From: Kouretas, Malgorzata E CIV USARMY ARDEC (US)
To: [Lawyer, Dennis](#)
Cc: [Krasnow, Nicholas D Jr CIV USARMY \(US\)](#)
Subject: [External_Sender] RE: RE: Department of the Army, Request for Additional Information Concerning Application for a License Amendment, Control 601500, Lic. No. SUB-348, Docket No. 04006377
Date: Wednesday, January 03, 2018 2:39:47 PM
Attachments: [Response to NRC RAI 14 Dec 2017.pdf](#)

**SUBJECT: Response to Request for Additional Information dated 14 Dec 2017,
Control 601500, License No. SUB-348**

Encl: Table of Revised Screening Level DCGLs for Building Surfaces
Class 3 Sample Locations- Bldg. 315

Screening Level DCGLs for the Stated Radionuclides

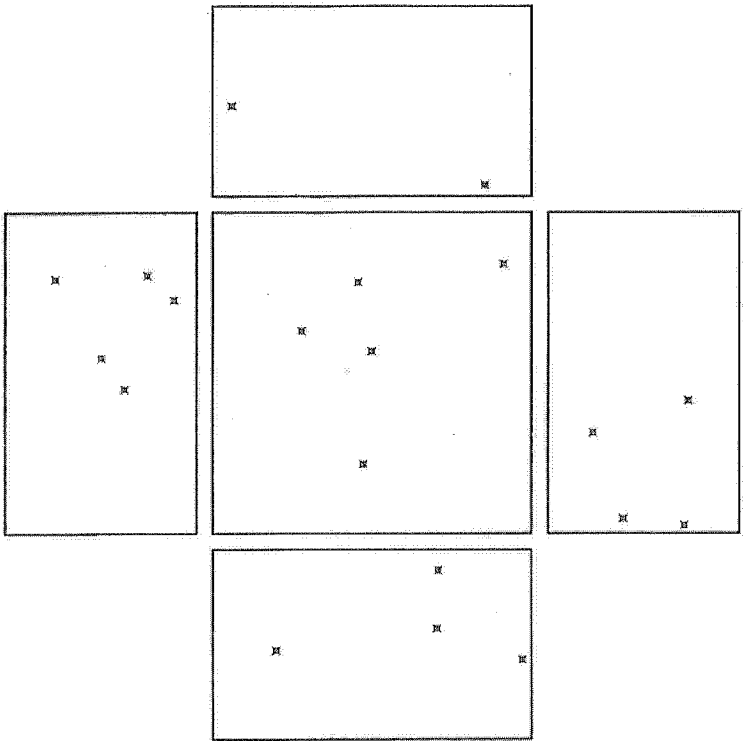
3. In section 3.3, you state that you calculated the Derived Concentration Guideline Level (DCGL) as 2,240 disintegrations per minute/100 square centimeters utilizing DandD, Version 2.1. Please submit a copy of that calculation.

3. The calculated screening level DCGL for U-238 (including use of the revised resuspension factor of $1E-6$ m⁻¹) is 1400 dpm/100 cm² and if using surveys for gross alpha emissions as the primary method of demonstrating compliance, this DCGL would be applicable. However, since the plan is to use beta emissions as the primary method of demonstrating compliance and the alpha to beta ratio for depleted uranium is 1:1.6 (NUREG 1757, Appendix O, Section O.3.3.5), the 2,240 dpm/ 100 cm² should be used as the screening level DCGL for depleted uranium. A copy of the D&D output summary report will be provided. In the meantime, attached is a table which shows DCGLs calculated using the revised resuspension factor guidance from the NUREG.

Title: Class 3 Sample Locations

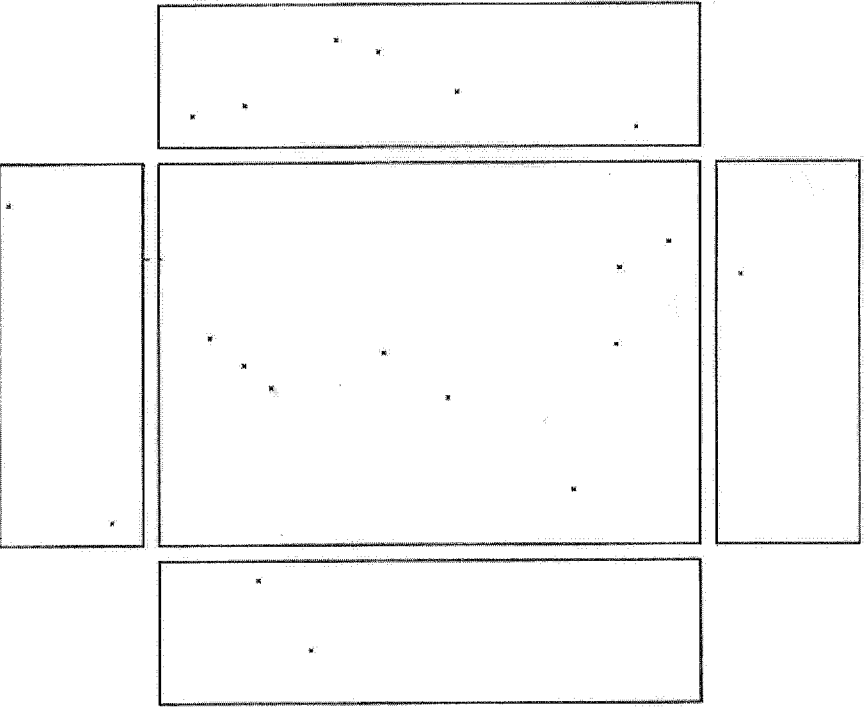
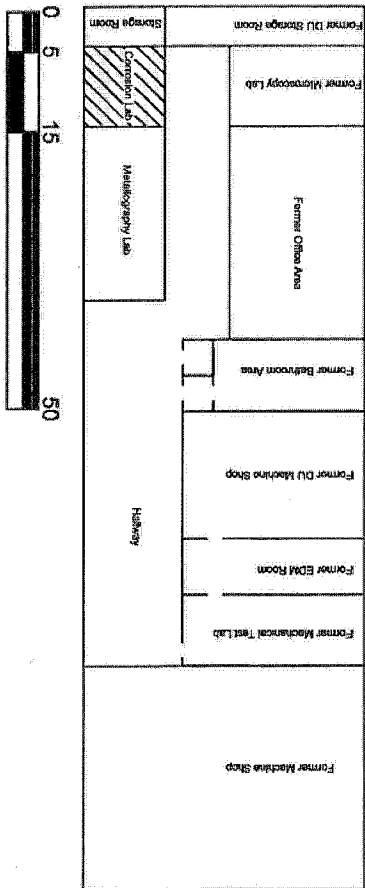
7. Please describe how you will pick random points for surveying. Also please provide maps and survey points associated with the proposed plan.

7. Random points are determined through the use of a random number generator to determine the appropriate X and Y coordinate from a pre-determine axis point for each survey unit. The attached figure will be included in the final plan with the random locations shown for any Class 3 survey units.
